Archway gyratory consultation; Islington Council's technical response

This letter forms Islington Council's technical response to Transport for London's (TfL) recent public consultation on the proposals for Archway gyratory. This is in addition to the Council's formal response letter to the Mayor of London from Councillor Claudia Webbe.

Proposals to introduce two-way traffic at Archway gyratory and relocate the Vorley Road bus stand

Note for London Buses

Areas around bus stops proposing to be removed (G and K/L)

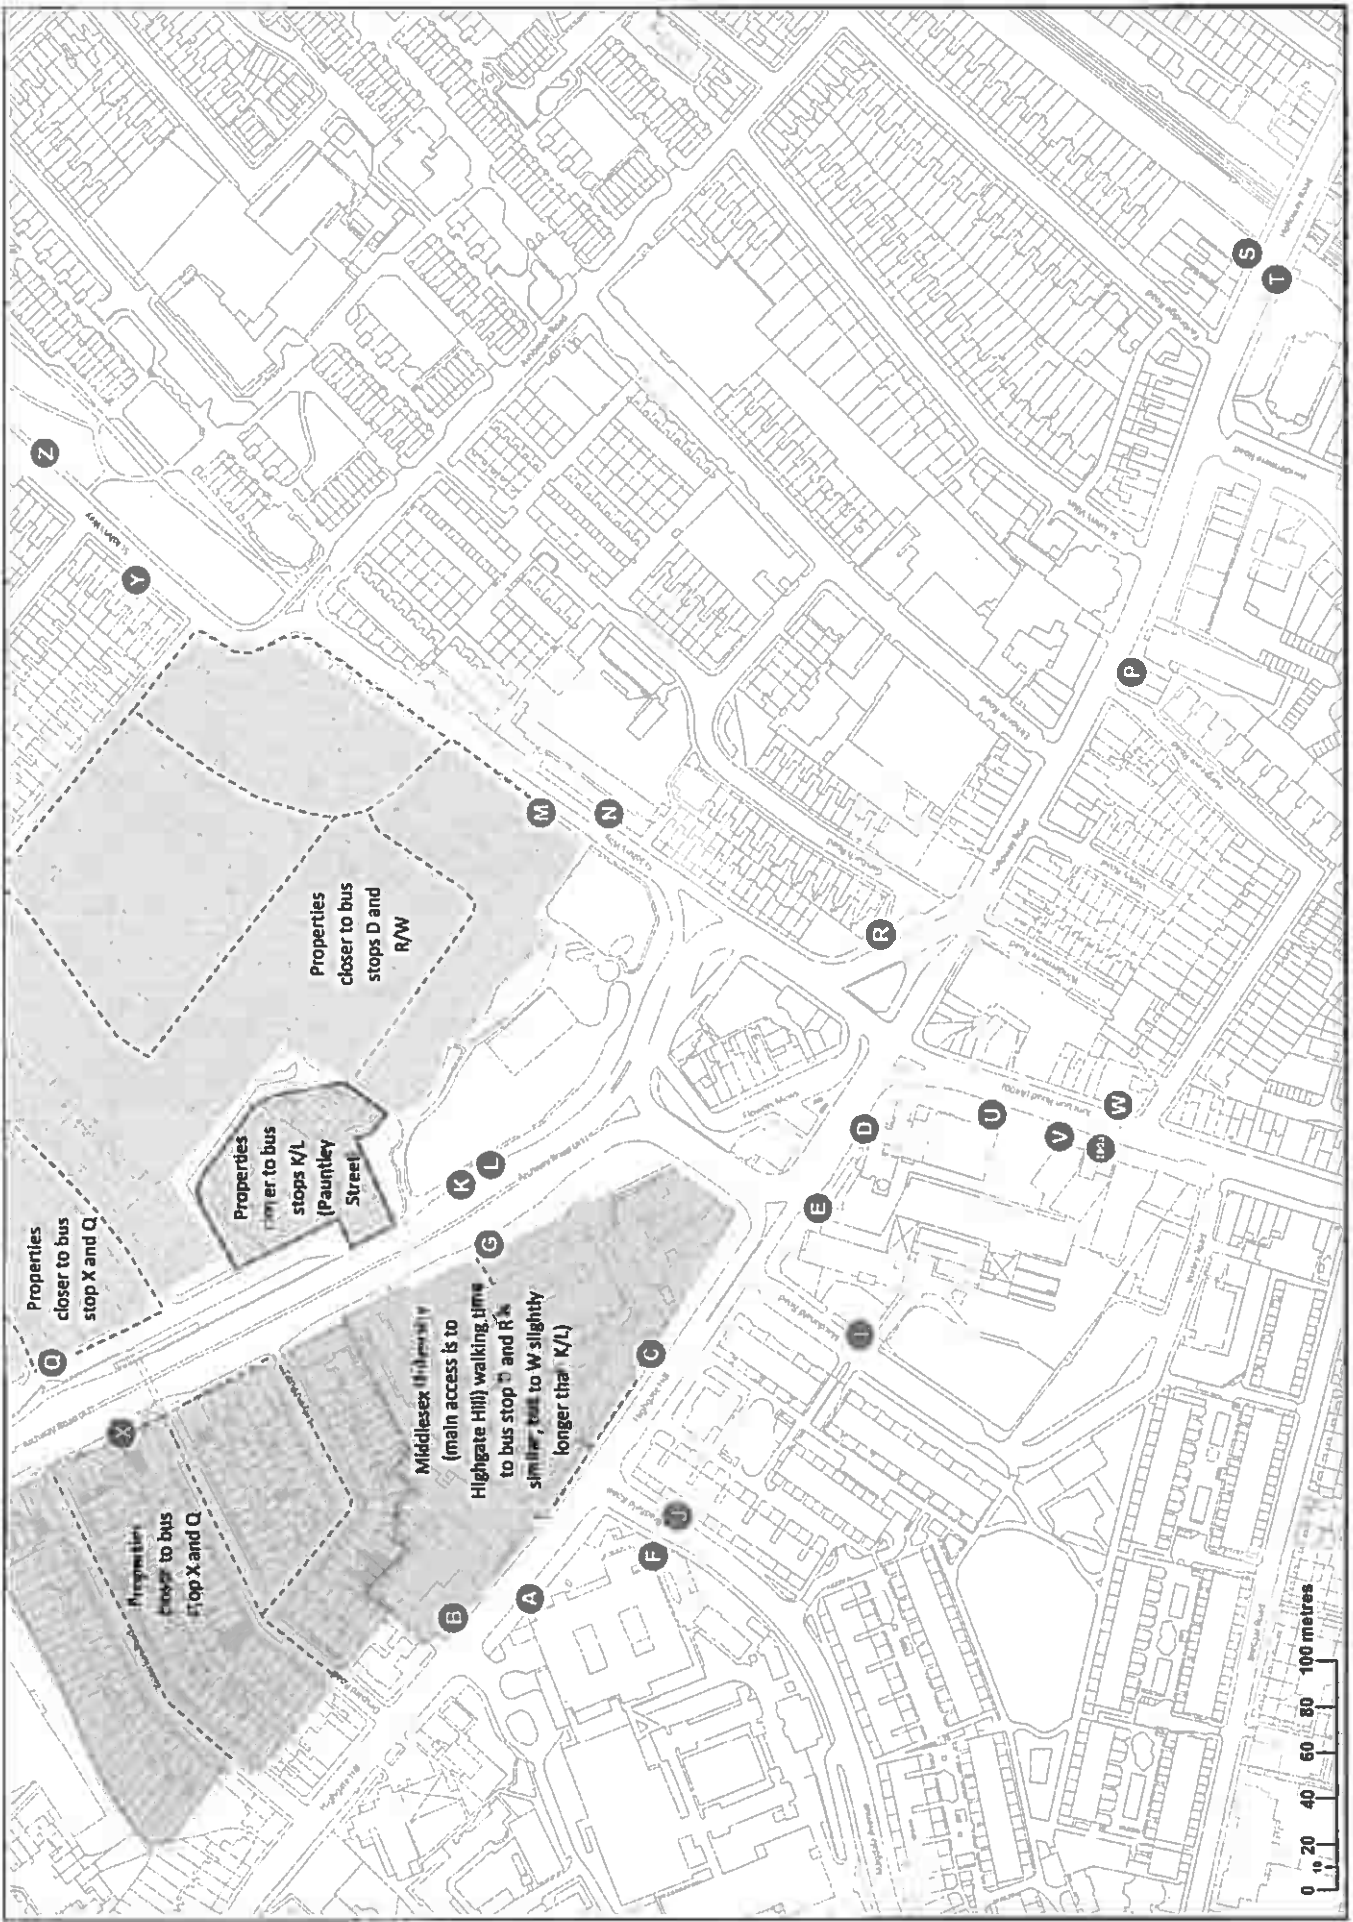
- 20 As a result of the relocation of stands for routes 17, 143 (or re-routed 4) and 390 to Archway Road, the current Stops G (northbound) and K/L (southbound) would have to be removed due to lack of space for both bus stop and bus stands. Therefore, services which currently use Stop G and K/L (Routes 43, 134 and 263) will no longer stop in these locations and will instead need to continue further north-westbound (stops X or Q) or southbound to the next stop (stops D, R or W). Whilst some small areas will be affected, the impact is very limited.

- 21 Stop X is the next available stop in the north-westbound direction and is a further 180 metres along Archway Road (near Despard Road). This will impact on those catching a north-westbound bus from Middlesex Archway Campus who will instead walk a further 135m to Stop X. However, the campus exit on Archway Road is predominantly for car park access and does not provide a main pedestrian access. From the main entrance to the Campus on Highgate Hill, stop D is at a similar distance as stop G, so removal of stop G will not lead to a longer walking distance from the Campus. For those from the Pauntley Street area catching a north-westbound bus on Archway Road, stop X is currently and will remain the closest bus stop (taking into account the underpass on Archway Road).

- 22 In the southbound direction, buses 43, 134 and 263 will continue to stop at stop W (134) or stop R (43 and 263), which will impact on relatively few residences.

The most affected residents are around Pauntley Street, who would need to walk a further 80m to stop Q (further up Archway Road) to catch a southbound service. Also users of the UCL Campus will experience a slightly longer walk to the southbound bus stop on Junction Road (W).
